WATTS BAR NUCLEAR PLANT (WBN) - RESISTANCE TEMPERATURE DETECTOR (RTD) BYPASS LOOP ELIMINATION AND EAGLE 21 ELECTRONICS UPGRADE - STATUS UPDATE

WATTS BAR NUCLEAR PLANT (WBÑ) - UNITS 1 AND 2
RTD BYPASS ELIMINATION - RESPONSE TO NUCLEAR REGULATORY
COMMISSION'S (NRC) REQUEST FOR ADDITIONAL INFORMATION

WAT/WBT THERMOWELL STRUCTURAL EVALUATION

VERIFICATION AND VALIDATION PLAN FOR THE
EAGLE 21 SYSTEM UTILIZATION - RESPONSE SUMMARY

Fig. 1 COLD Leg Thermowells

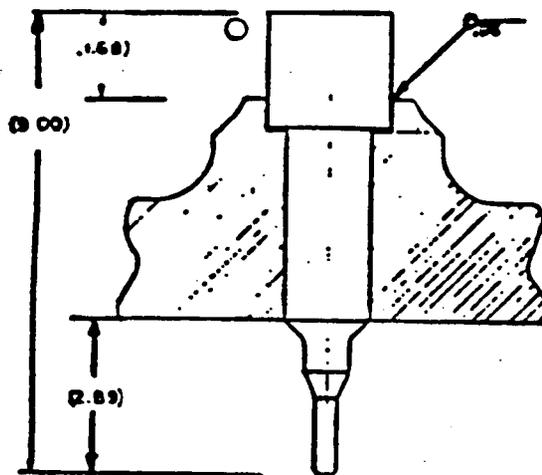
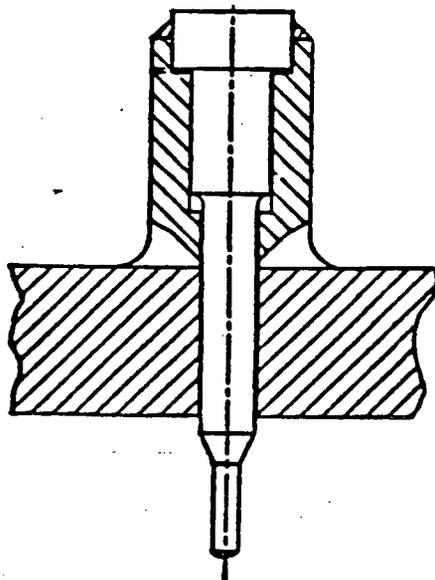
Q.2 The staff requires more information relative to the structural integrity of the narrow range and wide range Reactor Coolant System (RCS) temperature sensors (RTDs) which will be mounted in thermowells that protrude into the RCS hot and cold legs (Reference letter from J. A. Domer to Director of NRR, "Watts Bar Nuclear Plant - RTD Bypass Loop Elimination/Utilization of Eagle 21 Electronics - FSAR Chapters 5 and 7," dated December 1, 1986). Provide a description and summary of results of

analyses and/or tests which were performed to demonstrate that the proposed thermowells will withstand all anticipated flow induced vibration loads in combination with all other loads which are identified in applicable portions of FSAR Section 3.9.3. Include a discussion of the possibility of thermowell wear and high cycle fatigue damage which could be caused by turbulent buffeting and/or vortex shedding. Describe what post-installation tests, if any, would be performed to ensure that acceptable margins exist to prevent local fluid flow velocities from producing turbulent flow loads in resonance with the natural frequencies of the temperature probes.

- A.2 See attached report, entitled, WAT/WBT Thermowell Structural Evaluation, dated July, 1987, Revision 1. This report describes and summarizes the analyses performed to demonstrate the structural adequacy of the thermowells when subjected to pressure loadings, hydraulic steady flow loads, vibratory loads due to turbulent buffeting, vortex shedding, pump pulsations and seismic excitations, and post-installation tests are not considered to be necessary.

From the thermowell geometries shown above, it is obvious that the most critical sections are the root of the 0.4" tip sections where the thickness are the smallest. Therefore, it is suffice to analyze the stresses at this section only.

FIGURE 2
DESIGN, VERIFICATION AND VALIDATION PROCESS

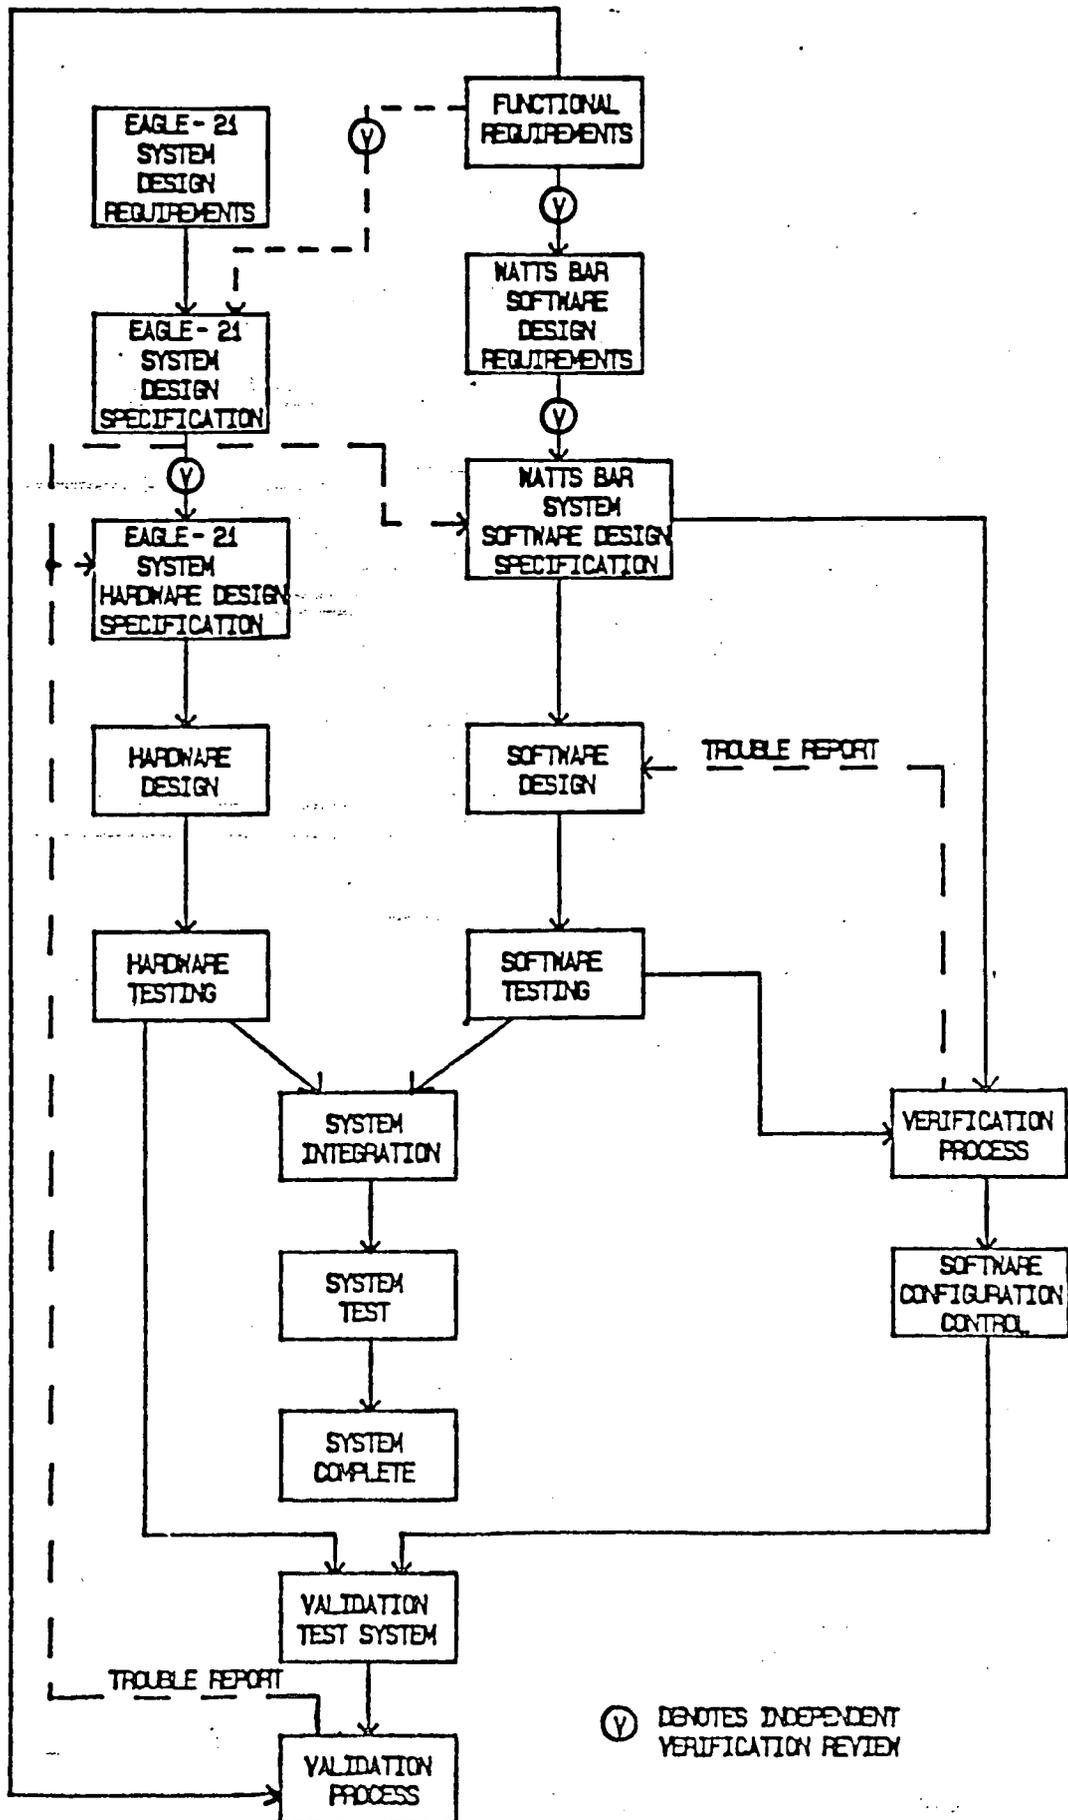
Item 2: Verify that independence was present during the formal design verification phase.

The Eagle-21 Design, Verification, and Validation Plan does not appear to provide for acceptable independence during the software verification process.

On page 10 of the referenced Audit Report on Verification and Validation Plan for the Eagle-21 System Utilization, dated April 27, 1987, it is stated, "The staff believes that the requirements of Appendix B of 10 CFR 50 take precedence over standards cited by the manufacturer in this area. Appendix B states in part that persons and organizations performing quality assurance functions shall report to a management level such that the required authority and organizational freedom include independence from cost and schedule."

Figure 2 illustrates the integration of the system verification and validation process with the system design process. The verification process may be divided into two distinct phases: verification of design documentation, and verification of software.

As shown on figure 2, independent verification of design documentation is performed during the design stage. For example, independent verification will occur to ensure that the translation from the Functional Requirements to the Software Design Requirements has been performed properly and thoroughly.

Figure 2 illustrates where an independent review and signoff will be conducted during the design process. Verification of the design documentation will be completed prior to the implementation and test phase.
